FIELD SAFETY NOTICE / PRODUCT NOTIFICATION

Subject: ExacTrac 6.0 Patient Positioning System:
 Display of potentially incorrect Digitally Reconstructed Radiograph (DRR) for x-ray correction and verification.

Product Reference: ExacTrac versions 6.0.0 through 6.0.5
 (Versions 6.0.0; 6.0.1; 6.0.2; 6.0.3; 6.0.4; 6.0.5)

Brainlab Identifier: **CAPA-20150713-001446**

Figure 1: X-Ray Fusion – bony fusion to DRR to determine the shift to desired patient position.

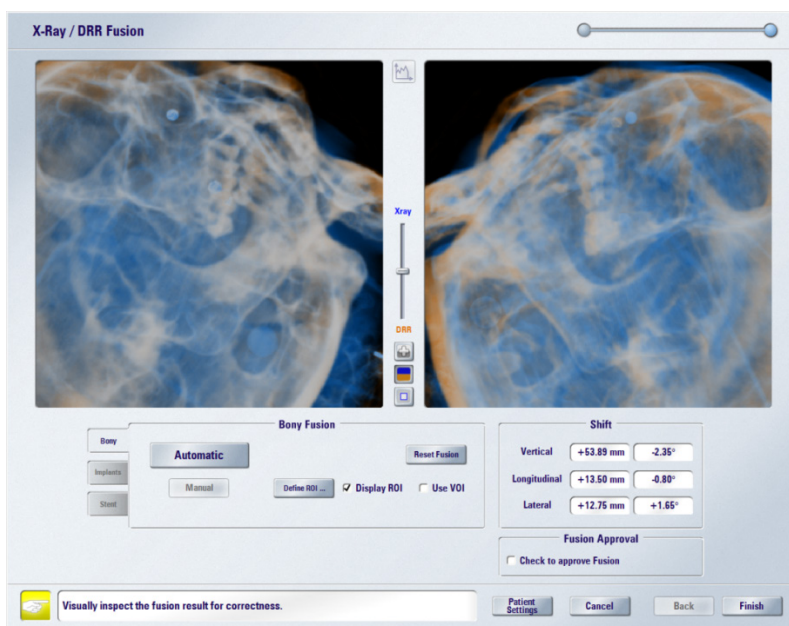
This issue affects X-ray correction and verification based on bony fusion to the DRR. The X-ray images acquired for current patient positions are not affected and still correct even if this issue occurs. Due to the unique signature of the patient anatomy in an X-ray image to distinguish an individual patient, a mismatch between the actual patient X-ray and an incorrect DRR simultaneously displayed at the fusion should be visible to the user. Only if the mismatch of displayed patient image data in ExacTrac is not discovered by the operator, the incorrect DRR might be used for image fusion to the acquired x-ray images, potentially resulting in the calculation of an incorrect shift.

Applying such an incorrect shift might result in a patient and treatment target position at the linear accelerator (linac) that is different than intended. As a consequence the treatment dose might be delivered to a region different from the intended target region. If the deviation exceeds clinically acceptable limits, **this could result in ineffective treatment, serious patient injury or even death of the patient.**

As generally required, always verify that the correct DRRs for the current patient are displayed in ExacTrac and an accurate fusion to the X-Ray images is possible for patient positioning.

In case incorrect DRRs would be displayed, exit and re-start the ExacTrac software.
